Broadcast Products Technical Bulletin 20-2007-180

DATE: **September 24, 2007**SUBJECT: **REUSE RX-46B BOARD WHEN REPLACING
BHB BOARD**MODEL: **BKM-142HD**SERIAL NO: **ALL**

Figure 1

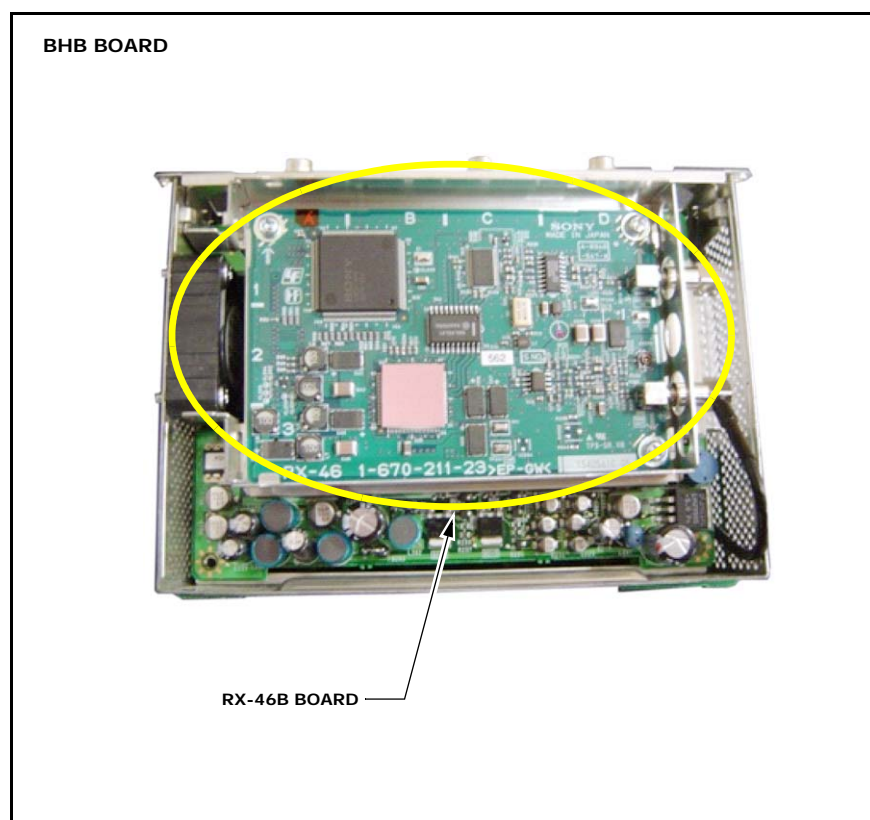
The new BHB board does not contain the RX-46B board, and the RX-46B board is no longer available as a service part. (See Figure 1.)

When you replace the BHB board, remove the RX-46B board from the former BHB board and install it on the new board.
